ADDENDUM #1

RE: Diamond/Douglas Parking Lot Improvements

New Mexico Highlands University
project no. 09-059

EXHIBIT A

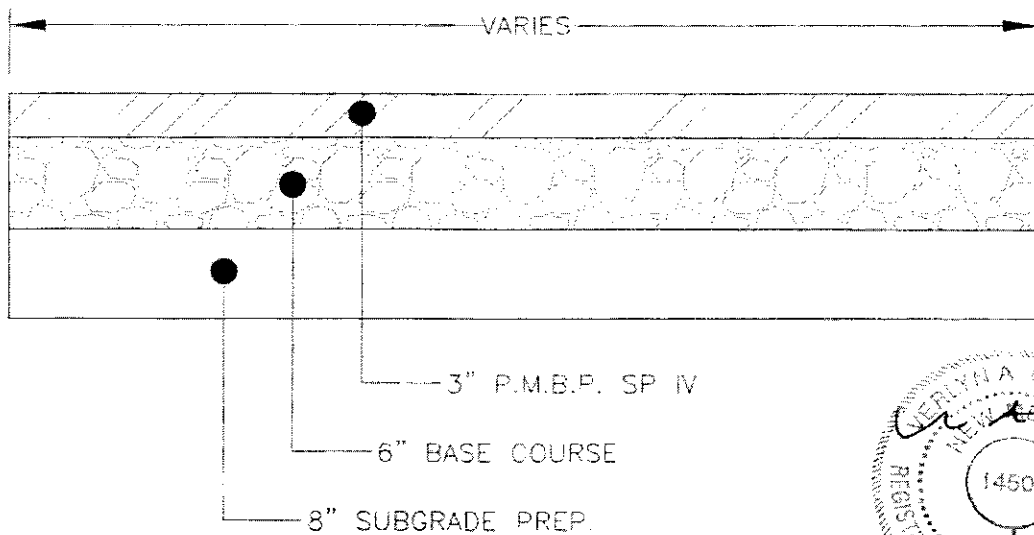
- 1) Sheet C-2 – General Note No. 36 shall read “All Borrow (fill) material for this project shall consist of an Engineered Fill material. The contractor shall provide submittals to the project engineer for review prior to construction.”
- 2) Sheet C-3 – In the Summary of Quantities, the NMDOT Item No. 451060 – Concrete Pavement – 6” shall be replaced by NMDOT Item No. 422270 – Plant Mix Bituminous Pavement (PMBP) SP IV – 3”.
- 3) Sheet G-1 – Key Note number three shall read “New 3” Asphalt Paving Surface” **NOT** “New 6” Concrete Paving Surface”.
- 4) Sheet D-1 – Replace Typical 6” Concrete Section with Typical Asphalt Paving Detail shown on Exhibit A attached hereto.

FOR SHEET D-1
REPLACE TYPICAL 6" CONCRETE SECTION
MARCH 3, 2010

TYPICAL ASPHALT PAVING DETAIL
